BULLETINS: SERVICE AND TECHNICAL PARTS, WARRANTY, ORGANIZATION.

P.J. GRADY INC. (631)589-6224 (800)350-7429 FAX (631)589-6241

SERVICE BULLETINS - TECHNICAL

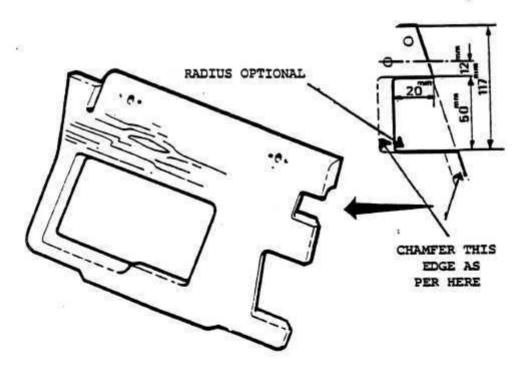
From V.I.N. 2309, a recess has been cut out of the right rear bulkhead panel to accommodate the wiring harness. See the diagram below.

This modification may also be made on earlier vehicles to improve harness routing.

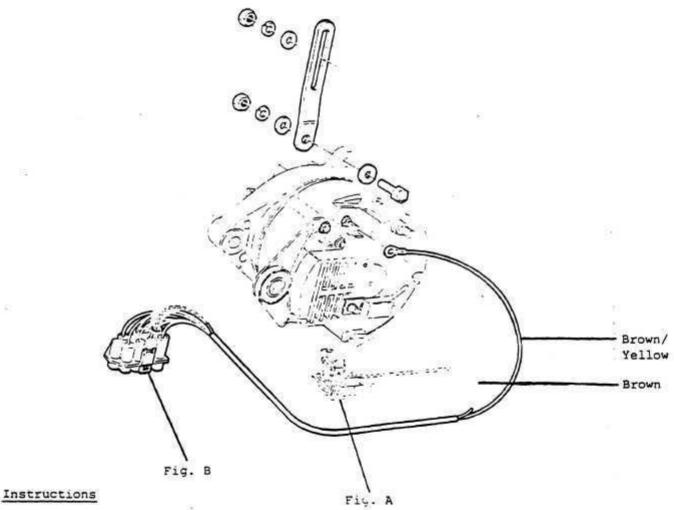
If alternator replacement becomes necessary on vehicles prior to V.I.N. 4539, the alternator mounting and wiring must be modified according to the attached instructions.

- Disconnect battery.
- 2. Remove existing alternator and bracket.
- 3. Cut off original alternator plug. (See Figure A.)
- Remove harness sheathing back to 1 inch before oil pressure sender break out to exposing brown wire and brown/yellow tracer wire.

- 5. Cut back brown wire to remaining harness sheathing.
- Disconnect blue engine harness plug (Figure B.) and cut back brown wire to sheathing.
- 7. Drill out eyelets of brown wires to 8 mm (charging wires B+).

- 10. Fit new eyelet to brown/yellow wire.
- 11. Re-tape main harness with electrical tape.
- 12. Fit the Motorola Type 90A Alternator using the modified adjusting bracket Part No. 110102 which is fitted in reverse position to the original bracket i.e., adjusting or slide portion to be bolted to the engine crankcase, fixed end of the bracket to the alternator end cover.

Fig. 5

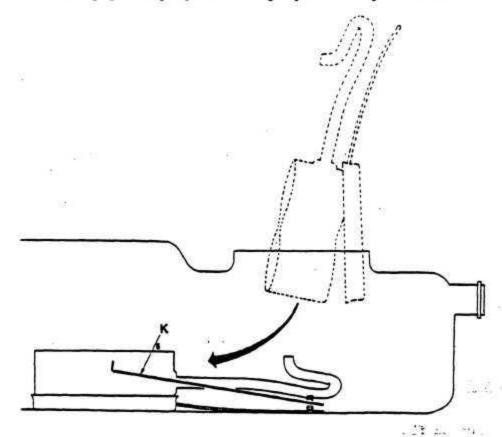
A modified new baffle Part No. 110155 for the fuel tank has been introduced as of V.I.N. 4782.

- Fit and position outer spring K under fuel flex feed hose (on baffle) and onto stud on base of fuel tank. (Do not locate spring on baffle edge at this stage.)
- Loosely fasten baffle and (2) two baffle retainer springs to stud in fuel tank base.
- 7. Locate hooked legs of retainer spring outer to rim of baffle.
- Finally tighten M6 nut to secure baffle and retainer springs to fuel tank stud L (Do not over-tighten.)
- 9. Connect fuel feed pipe to pump and fit pump assembly to tank.

Figure 1
OLD CONDITION

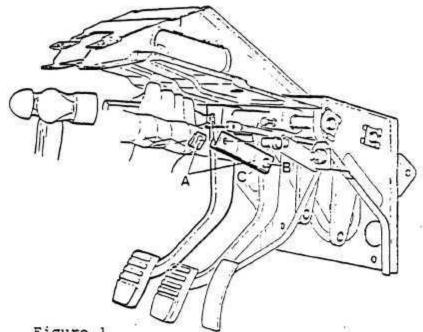
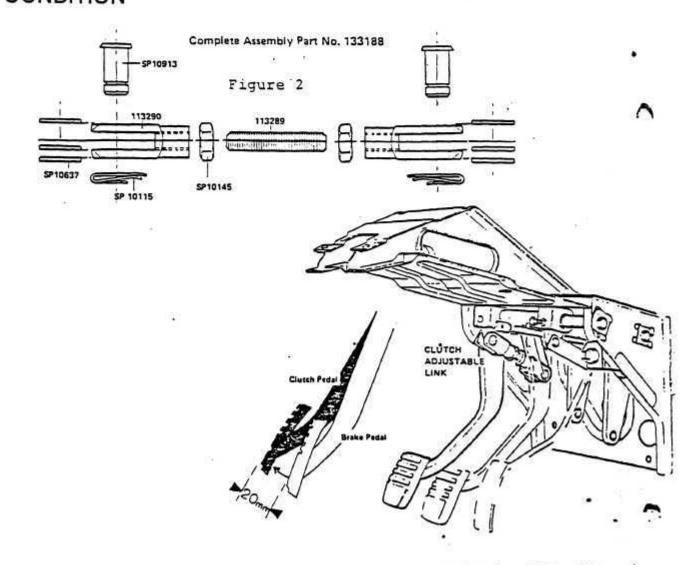
The clutch pedal stop bolt and weld nuts must be removed to permit the pedal to be raised. To carry out this operation, the following procedure should be observed (Figure 1).

- C) Unscrew the 10 mm clutch pedal stop bolt from the top of the pedal box and discard.
- D) Using a hammer and sharp chisel carefully shear off the 10 mm clutch stop nuts welded on both sides of the pedal box (Figure 1).
- E) Assemble the adjustable clutch link (Figure 2) (Part Number 133188). Adjust both clevis ends evenly on the threaded rod so as when the link is secured the clutch pedal is 20 mm (3/4") higher than the brake pedal (Figure 3).
- F) With the link adjusted and positioned install the clevis pins.
- G) Reinstall spring clips to retain clevis pins, and tighten lock nuts.

FIGURE 2

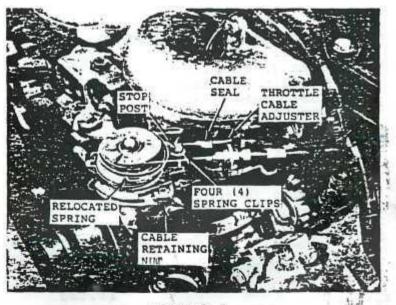
Install the supplied seal (P/N 111183) on the throttle adjuster as shown in Figure 2.

10. Remove the outer throttle return spring. On cars equipped with automatic transmissions as illustrated in Figure 2, it will be necessary to remove "E" clip, bushing and plate.

Modify the outer return spring by taking the upper end of the spring and passing it over the top and under the first coil. (Figure 2)

- 11. Install the four (4) internal tooth spring clips supplied (P/N SP10882) to groove in return spring stop post, as shown in Figure 2.
- 12. Reinstall the throttle cable to the throttle spool and adjust. Ensure the lower end of spring is placed under the spring clips install in Step 11.
- 13. With the throttle spool in full rest position the cable should be taut but not influence throttle spool position.
- 14. To achieve the above condition loosen 8 mm cable retaining nut located on the bottom of the throttle spool and pull on the throttle cable end until taut. Retighten the nut.

FIGURE 3

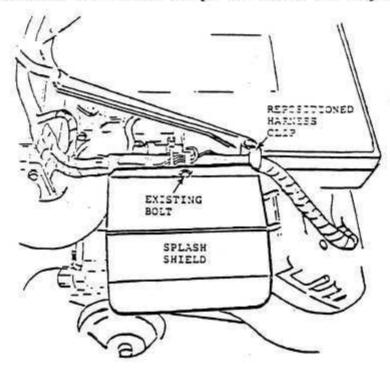
- 16. Install the splash shield (P/N 111184) to the air inlet manifold using existing bolt as shown in Figure 3. Ensure the installation is firmly located and free from vibration.
- 17. Relocate the wiring harness away from edge of splash shield using one of the harness retention clips as shown in Figure 3.
